From: John Talbott <John@bardlaw.net>
Sent: Tuesday, December 6, 2022 6:13 PM
To: St Germain, Dante
Subject: FW: Waldman/Johnson
Attachments: Atty-Rueff-Affidavit-Trees.pdf

STATEMENT OF COMPLIANCE/LETTER OF EXPLANATION FOR FLOYDS FORK OVERLAY DISTRICT GUIDELINE 4

Project Name/Location: 1614 Johnson Road
Attached single family and multi-family residential

Subject: Floyds Fork DRO 22-MSUB-0004

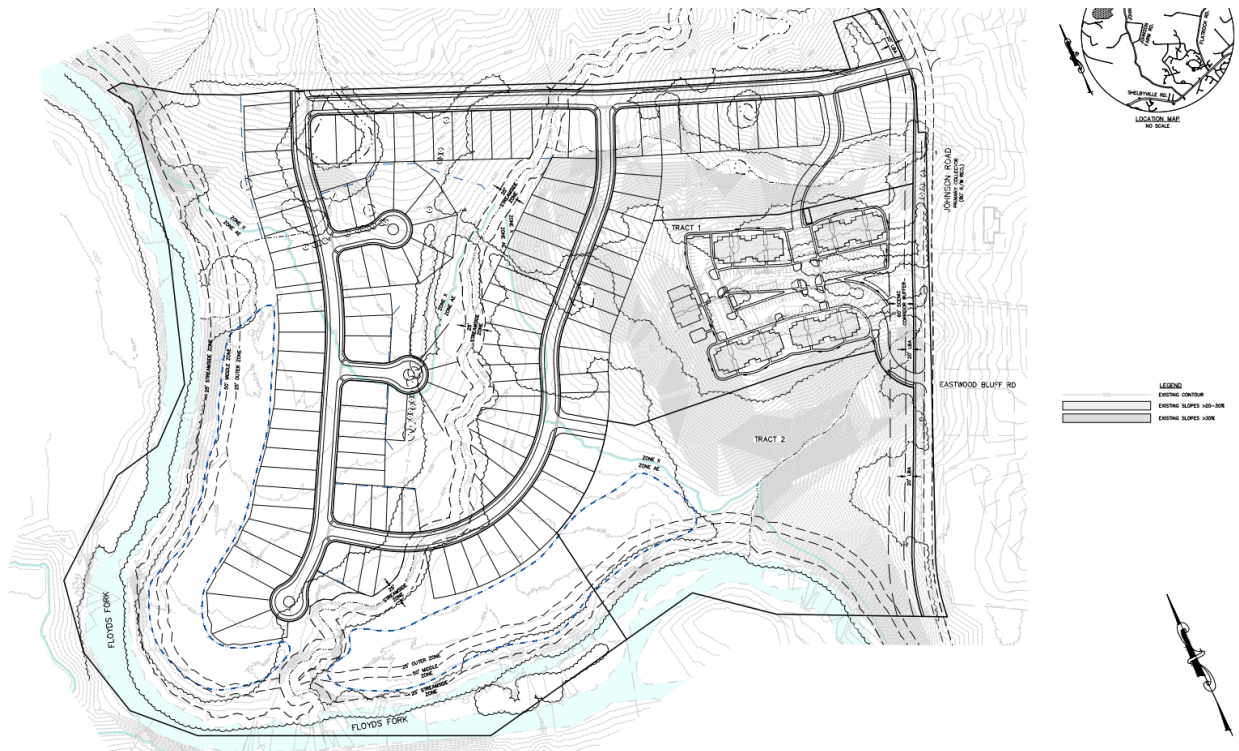
The specific issue addressed in this Statement of Compliance/Letter of Explanation concerns Floyds Fork Overlay Guideline 4: Hillside, to address staff’s PDS Agency comment #12.

To comply with FFDRO Guideline 4(a) and (b), the Applicant has designed this subdivision in such a way as to maximize development in the areas that do not have 20% or greater slopes, as shown by this “Existing Steep Slopes Exhibit” created on November 21, 2022:

In that exhibit, which has been submitted on ACCELA, the gray shaded regions connote the existing slopes of 20% or greater, and the majority of those regions are undisturbed by the proposed development.
